Planning Commission Work Session

RZN22-0004 Glade Spring Crossing

- Request
 - Rezone 44+ acres from RR-1 to PR
 - Construct public streets
 - Develop single- and attached-family dwellings
 - 176 units (appx. 4 units per acre)
 - Mix of restricted affordable and market-rate housing
 - Regional stormwater management
 - Major subdivision public hearing to follow if approved

PEDESTRIAN CIRCULATION AND TRAIL EXHIBIT

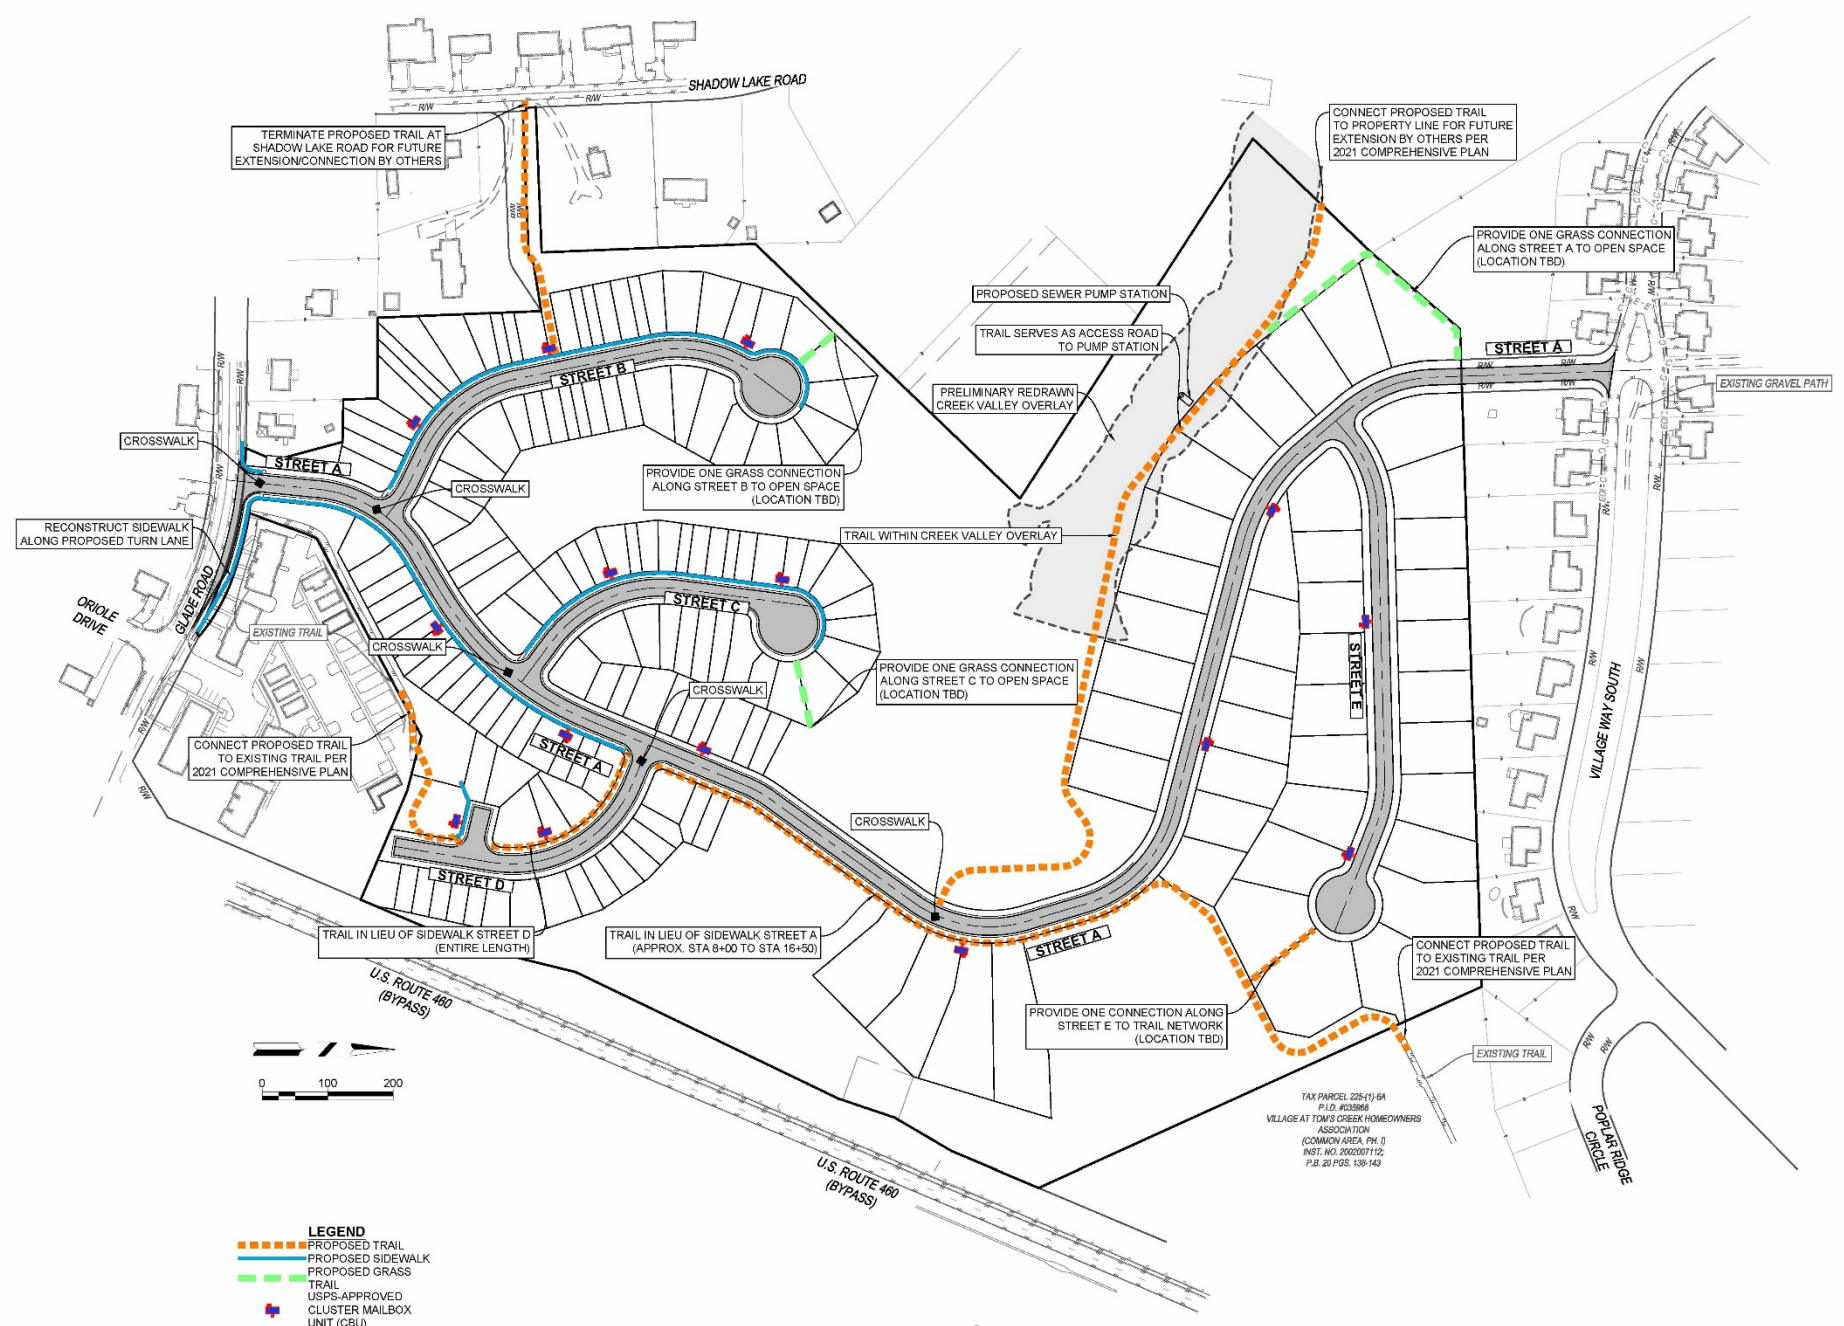
- Access to open space
 - Access is required to private open space by paved path, or gravel
 - Proposed access to open space is grass trails

- Trails required; construction standards
 - Trails provided in development
 - Required to be 10' pavement; with min 4' separation between trail and back of curb or edge of pavement
 - No typical section was provided showing road and trail, so it is unclear what the separation is
 - Application shows that min. proposed separation for sidewalks is 3' (requesting a variance)

FIGURE B(1)-12 CULS-DE-SAC AND TURNAROUND DETAILS

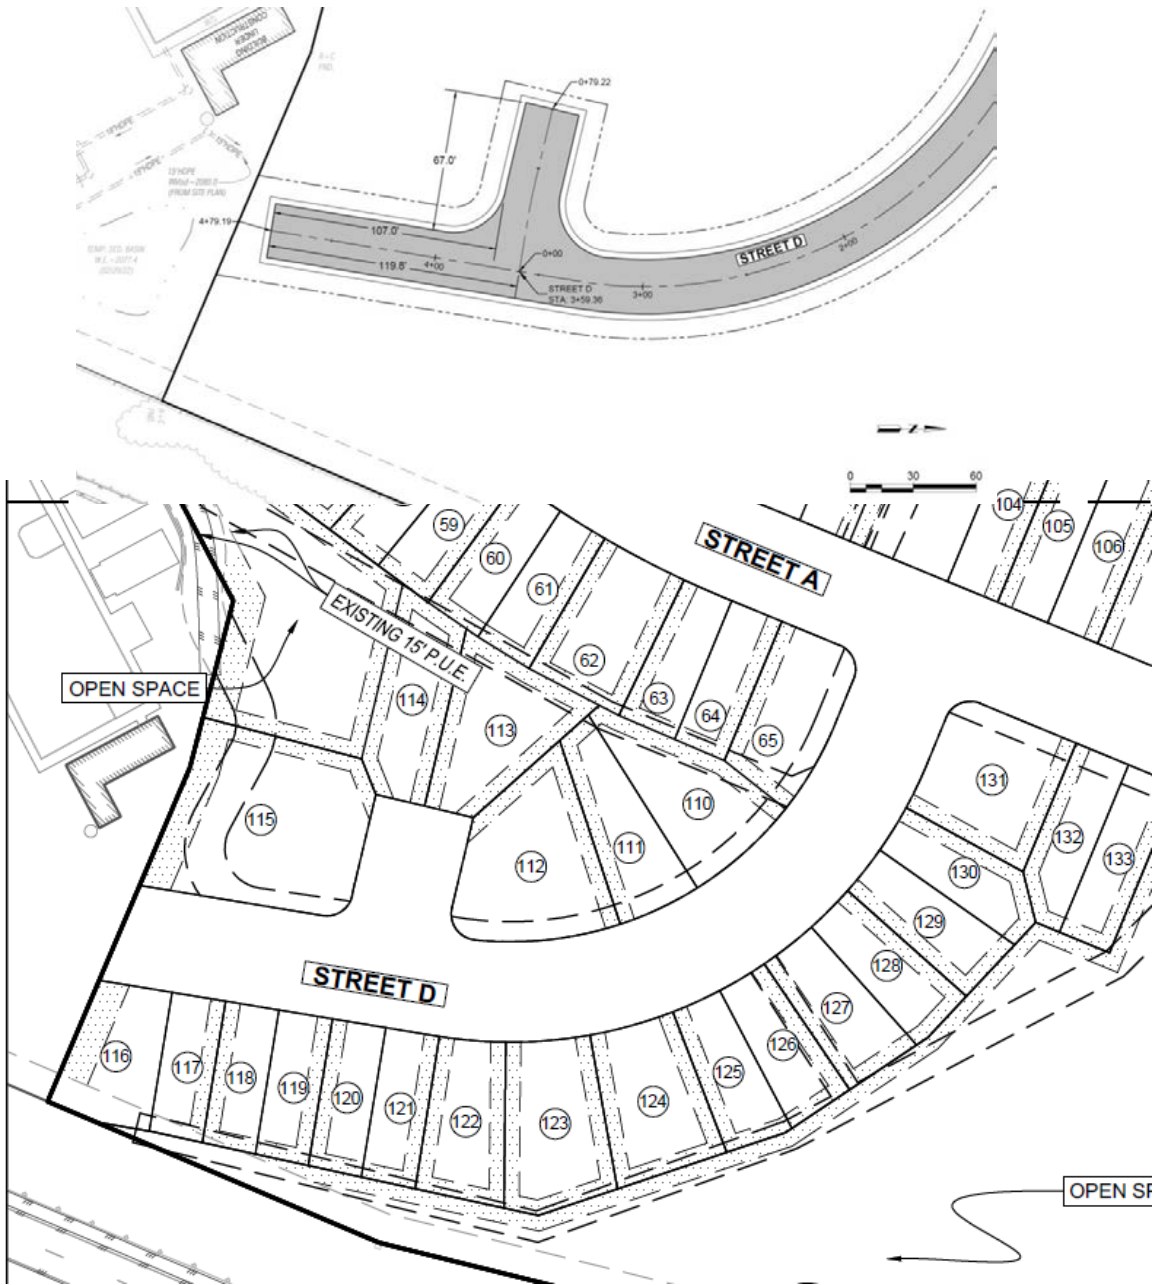
- Cul-de-Sac
 - Applicant requests T- or Y-turnaround in lieu of bulb cul-de-sac
 - Proposed turnaround meets minimum VDOT standards for a “branch” type
 - May result in awkward maneuvering for vehicles at the end of the proposed street

Options for street grade and landing length; some require grading on adjacent property

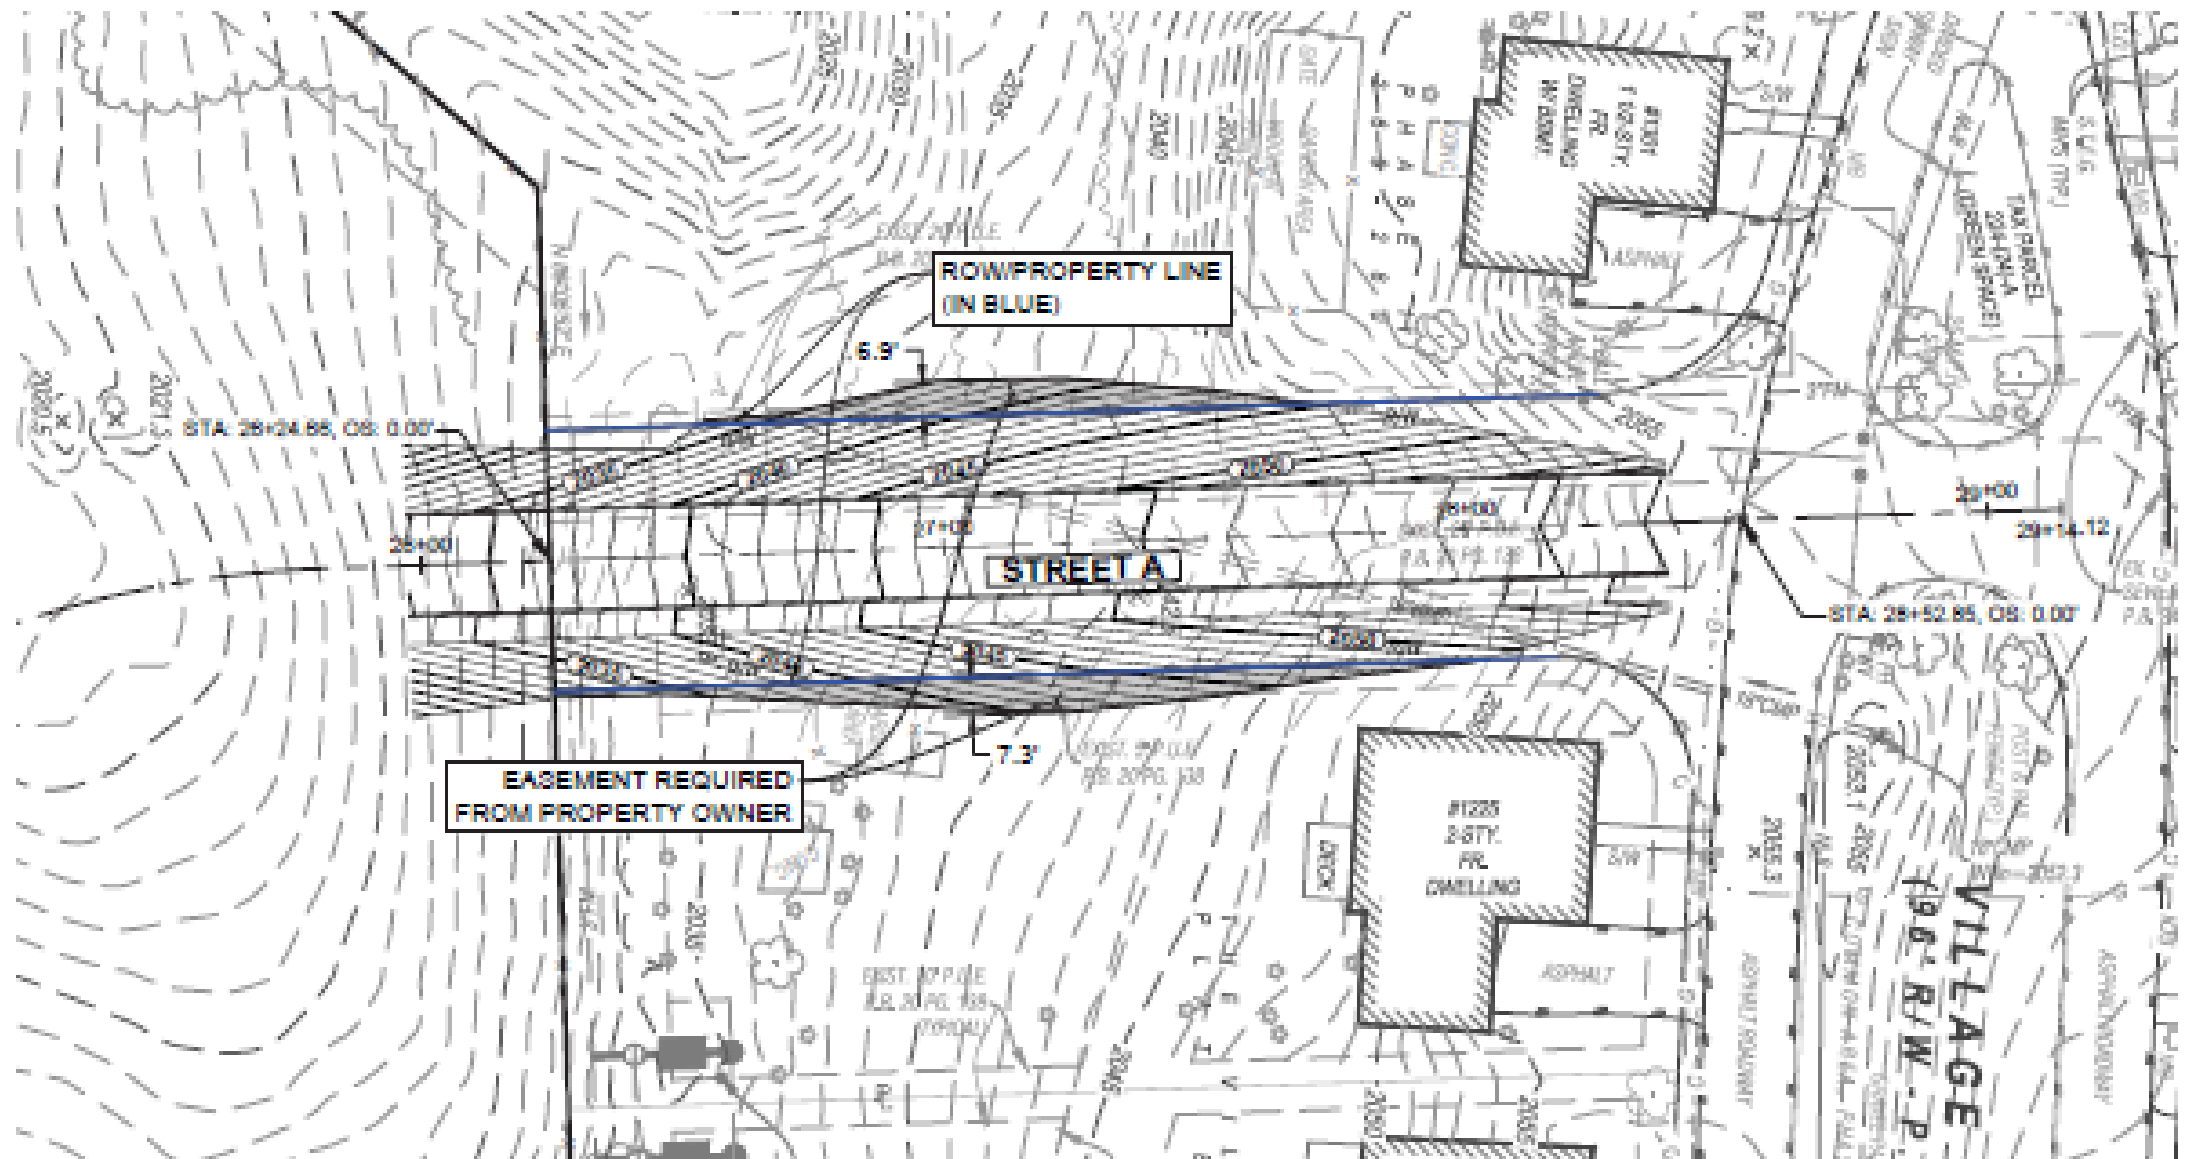
- Street Grades & Landings at Intersections
 - Applicant requests steeper street grade for a portion of Street A approaching the intersection of Village Way South
 - Applicant requests a shorter landing than standard at the intersection due to grading
